Access Compliance Report

Public Rights-of-Way

(Curb Ramps)

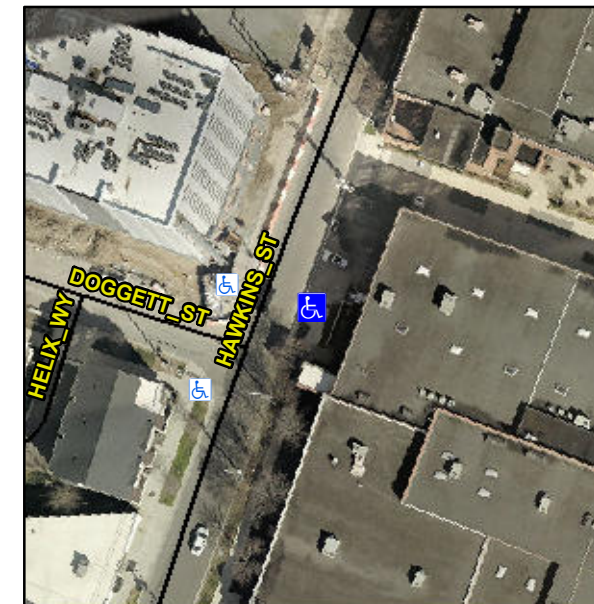
Intersection ID: 14120	Main Street: HAWKINS_ST	Cross Street: DOGETT_ST	Location: NE
ADA ID: 4944ABCC5369	Ramp Type: Perp	Initial Pass/Fail: Fail	Overall Compliance: No
Severity Score: 25			
Codes/Mitigation Info/Possible Solution		Field Measurements/Component Compliance

Compliance	Description	Data	Compliance	Description	Data
N/A	Ramp Length (in)	92.0	No	Ramp Slope (%)	14.2
Yes	Ramp Width (in)	80.0	Yes	Ramp XSlope (%)	0.5
N/A	Flare Type LT	N/A	N/A	Flare Type RT	N/A
N/A	Flare Slope LT (%)	N/A	N/A	Flare Slope RT (%)	N/A
N/A	Flare Traversable LT?	N/A	N/A	Flare Traversable RT?	N/A
N/A	Landing Length (in)	N/A	N/A	DWS Provided?	N/A
N/A	Landing Width (in)	N/A	N/A	DWS Contrast?	N/A
N/A	Landing Slope (%)	N/A	N/A	DWS Length (in)	N/A
N/A	Landing X Slope (%)	N/A	N/A	DWS Full Width?	N/A
N/A	Landing Curb? (Y/N)	N/A	N/A	DWS Offset (in)	N/A
N/A	Shared Landing?	N/A			
N/A	Gutter Ponding?	N/A	N/A	Gutter Slope (%)	N/A
N/A	Gutter Lip Ht (in)	N/A	N/A	Gutter X Slope (%)	N/A
N/A	Painted X Walk1?	No	N/A	Painted X Walk2?	N/A
	X Walk 1 Direction	To NW		X Walk 2 Direction	N/A
N/A	X Walk 1 Width (in)	N/A	N/A	X Walk 2 Width (in)	N/A
	X Walk 1 Slope (%)	3.0		X Walk 2 Slope (%)	N/A
	X Walk 1 X Slope (%)	5.9		X Walk 2 X Slope (%)	N/A

Remove & Replace Entire Ramp.

R304.2.2
